**CITY OF SEATTLE
ANALYSIS AND DECISION OF THE DIRECTOR
OF THE DEPARTMENT OF PLANNING AND DEVELOPMENT**

Project Number: 3012547
Applicant: Jodi O'Hare for Intracorp Real Estate, LLC
Address: 4545 8th Ave NE

Land Use Application to allow a 7-story structure containing 162 residential units. Parking for 97 vehicles to be provided at and below grade. Review includes 16,440 sq. ft. demolition of existing structures.

East facade

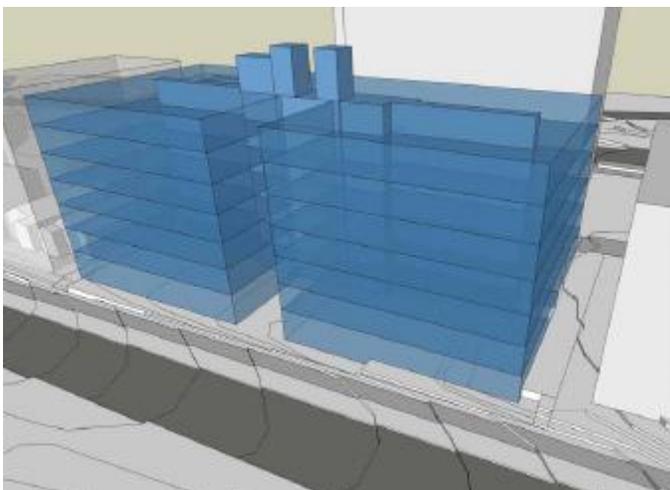
The first scheme (Option 1) showed a zoning compliant option with two buildings located over underground parking. Each building included a lobby and entrance from 8th Ave NE. A 10' separation was shown between the buildings, with setbacks that exceeded the minimum requirement at the side, front and rear property lines. This option included 154 apartments and 93 parking stalls. The applicant noted that this scheme offers an opportunity to step the buildings to respond to grade changes north to south, an opportunity to differently design the two buildings, and a large setback from the buildings across the alley. Challenges include a narrow courtyard between the two buildings, little modulation in the east facade, and the need for two lobbies and entrances.

East facade

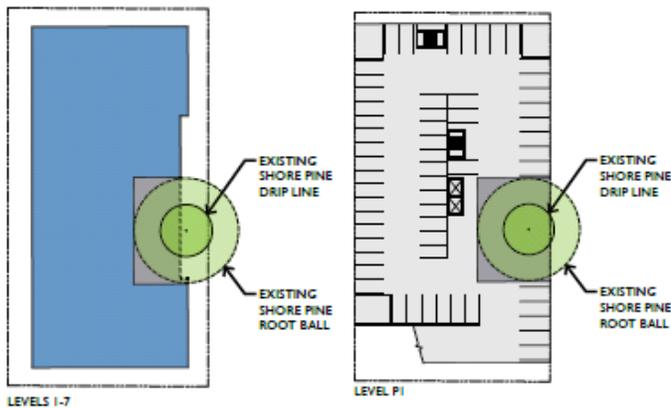
The third scheme (Option 3), and the applicant preferred option, showed a building with the front facing courtyard space rearranged to provide a wider break in the east facade, but providing less depth for a courtyard. The courtyard area at the east façade would be 15' from the property line and 4' offset from the rest of the front façade. The courtyard would be 87' wide. The departures would be similar to those required in Option 2. This option included 152 apartments and 93 parking stalls. The applicant explained that this design includes an east-facing open space that offers more light and air than the deep courtyard in Option 2, the open space responds to the park-like context across the street, the larger front setback offers the opportunity for gathering space and landscaping, and the building is lower than the maximum height. Challenges include the minimal depth of the courtyard and the need for departures from setbacks, structure width, and structure depth.

The applicant explained that an exceptional tree has been identified near the center of the site, near the east property line. The applicant has worked with an arborist and it appears that a tree protection area measuring twice the drip line would be required to maintain this tree. The applicant showed some graphics indicating the potential impact to the site design, parking, and proposed courtyard space.
